# Don Mouth Naturalization and Port Lands Flood Protection Project

Amendment To The March 2014 Environmental Assessment Report (EA 03 03 02)

April 2021

Figure A-10. Reach 1 (SDMA) Components Table & Plan (per EA) and Proposed Configuration

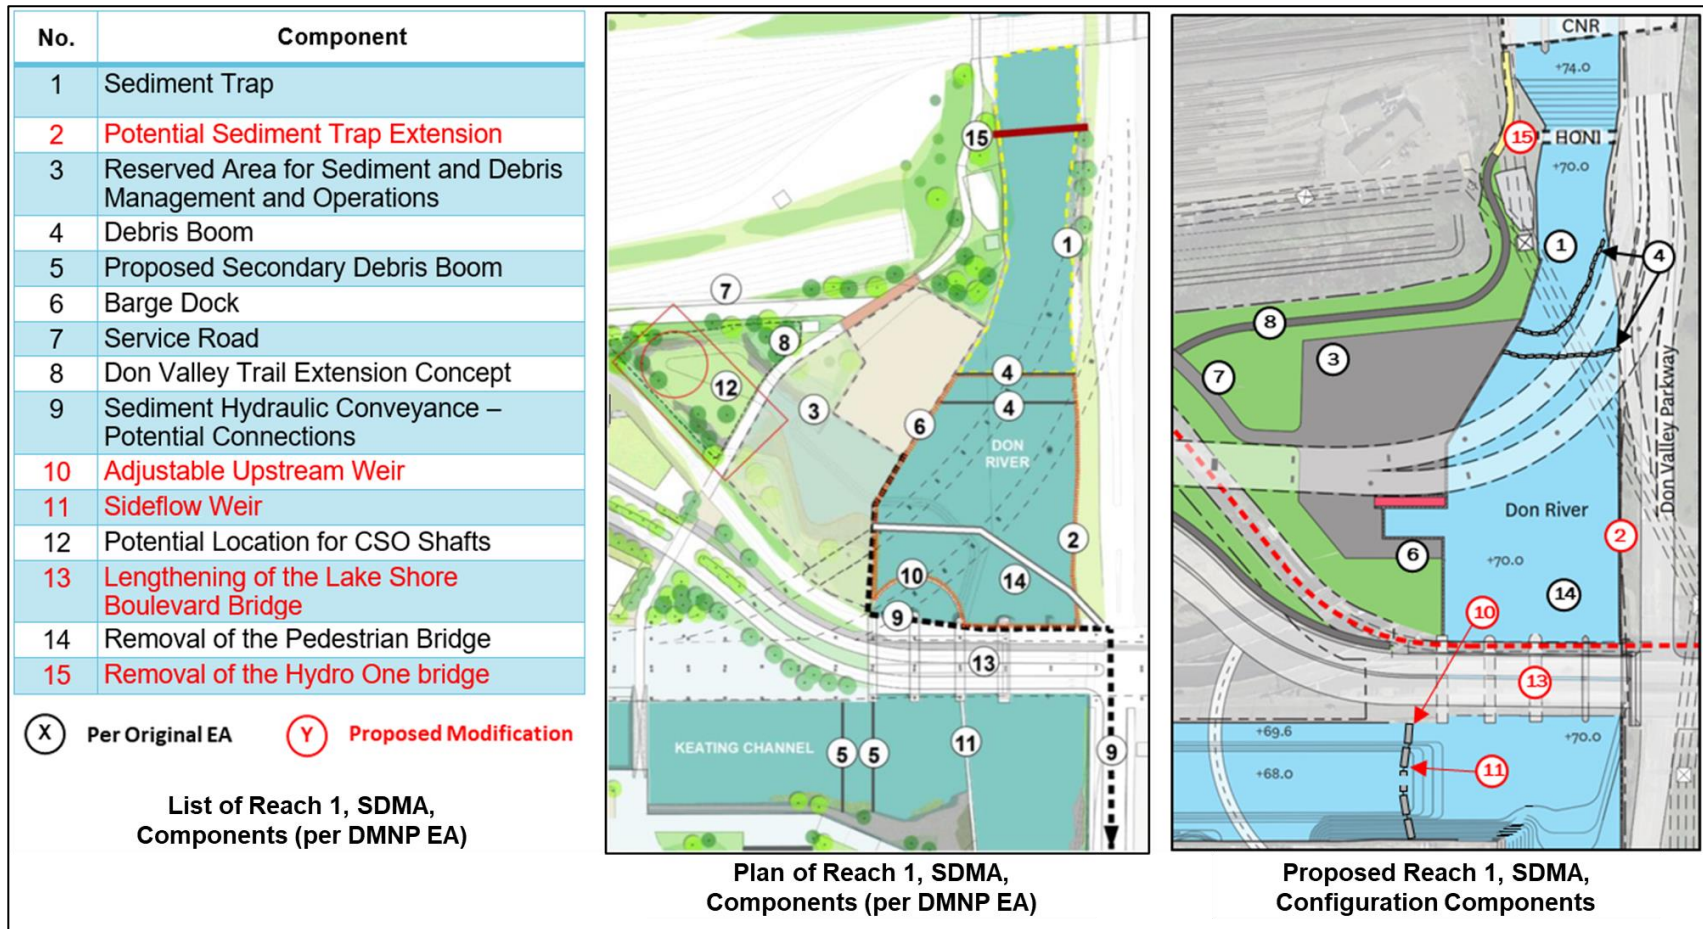
The EA provided a list of components within Reach 1 and the east end of Reach 2a. These components are listed in the table (included within Figure A-10). Components in **red font** are the ones to which modifications are proposed.

The plan in the middle of Figure A-10 was provided in the EA as a conceptual design for the SDMA. The Proposed Modifications are within the plan on the right side of Figure A-10, with changed components in **red bubbles**. The Proposed Modifications within Reach 1 pertain to the following components:

- Potential Sediment Trap Extension (represented by bubble #2)
- Adjustable Upstream Weir and Sideflow Weir (represented by bubbles #10 and #11, respectively)
- Lengthening of the Lake Shore Boulevard Bridge (represented by bubble #13)
- Removal of the Hydro One Bridge (represented by bubble #15)

The Proposed Modifications for Reach 1 will achieve Regulatory Flood Protection with a 50 cm vertical freeboard while lessening the total footprint of construction north of Lake Shore Boulevard.

The Proposed Modification will lengthen the Lake Shore Boulevard and Harbour Lead rail bridges from 2 bays to 4 bays. Each structure will have a length of approximately 98 m. Further, the soffit heights for the lengthened portions of the bridge will range between 76.801 and 77.960 m. Please refer to Appendix D for the general arrangement drawings for the four-bay Lake Shore Boulevard Bridge.

The Proposed Modification will reduce the channel width from the EA's upper limit of 120 metres to approximately 98 metres. This is to match the planned reduction of the Lake Shore Boulevard Bridge's length of 98 metres. The sediment trap will be designed to scour to a depth lower than what was originally considered in the DMNP EA to accommodate the Regulatory Flood flow.

The Proposed Modification will leave the bridge in place. The Don River, in the vicinity of the HONI Bridge, will be designed to scour to a depth lower than what was originally considered in the DMNP EA to accommodate the Regulatory Flood flow.

The Proposed Modification will replace the adjustable (upstream) and fixed (downstream) sideflow weir structures with a single detachable flow curtain. Please refer to Appendix E for slides detailing the detachable flow curtain.

**Figure A-11. Phased Construction Approach north of Lake Shore Boulevard**

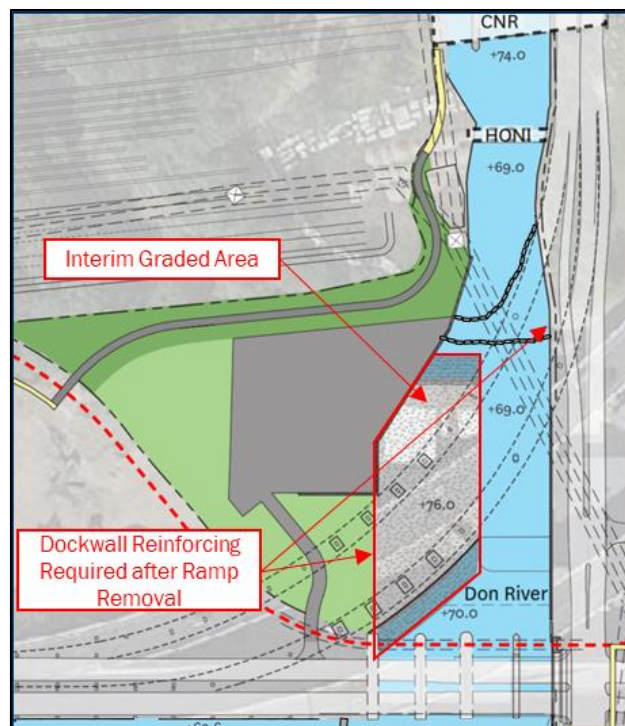
- The area behind the west dockwall (interim graded area as shown in Figure A-11) will be lowered to the pier cap elevation of the existing Gardiner to DVP ramps, and the existing dockwalls reinforced and lowered,
- Temporary rock revetments will be installed on the up and downstream side of this lowered area, and
- The existing riverbed will be dredged lower in most locations, except under the northernmost DVP ramp at the east dockwall due to clearance issues preventing interim reinforcement of that dockwall.

This interim phase will remain in-place until the overhead Gardiner ramps can be demolished. It will provide protection against the Regulatory Flood. Dredging will take place north of the Lake Shore Bridge during the interim phase approach, to maintain interim design depths. A detailed analysis for the dredging operation is currently under development. Regarding the SDMA works yard (west of the river within Reach 1), the intent is to proceed with most construction during PLFP, subject to determination of final Gardiner ramp layout. The duration of this interim phase is anticipated to be approximately 5 years.

Figure A-11 provides an overview of the interim phase that will be pursued as part of the PLFP Project. The remaining work, which includes full river excavation, dockwall reinforcement, and localized dredging will be pursued by the City of Toronto following the removal of the Gardiner-DVP ramps.

The Proposed Modification is possible as a result of advancing detailed design and value engineering to avoid incurring significant throwaway cost and risk by reinforcing the existing Gardiner-DVP ramp piers.

Figure A-12. Keating Channel Revetment and Habitat Shoals within PLFP

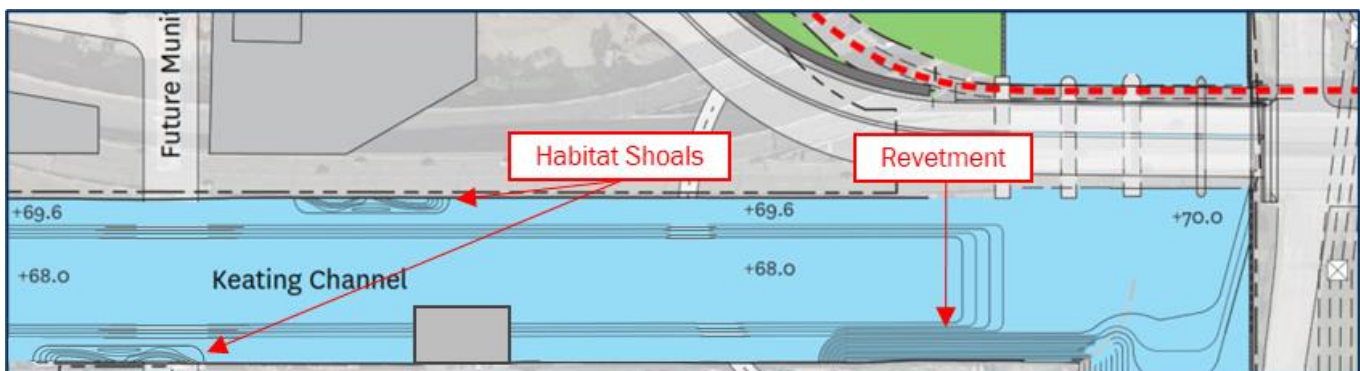
The Proposed Modification will defer full reinforcement throughout the entire channel and, instead, provide two habitat shoals and some localized revetment – for sections of dockwall requiring reinforcement to enable PLFP construction.

Figure A-12 provides an overview of revetment and habitat shoal placements that will be delivered as part of the PLFP Project.

The Proposed Modification is possible as a result detailed design which will ensure the stability of dockwalls within the channel. The original intents of the revetment placements were to stabilize dockwalls and provide aquatic habitat; both will remain intact and will progress in tandem with future development.
